Spare Parts Requirements for High-Voltage Battery – Observe Additional Measure Required (34/21)

Model Line: **Taycan (Y1A)**

Concerns: **Damping elements for high-voltage battery**

Front damping elements

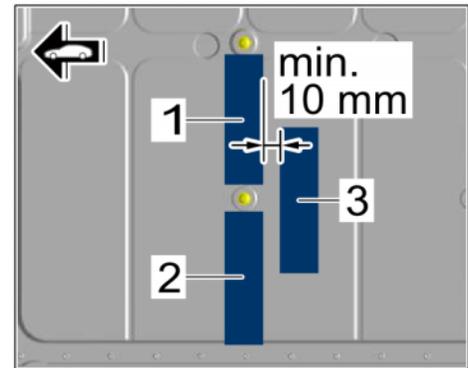
Work Procedure: 1 Check whether damping elements are installed on the high-voltage battery at the front left ⇒ *Front damping elements -1-* and right ⇒ *Front damping elements -2-*.

New damping elements must **not** be affixed if damping elements were not previously affixed. Otherwise, the high-voltage battery or underbody could be damaged.
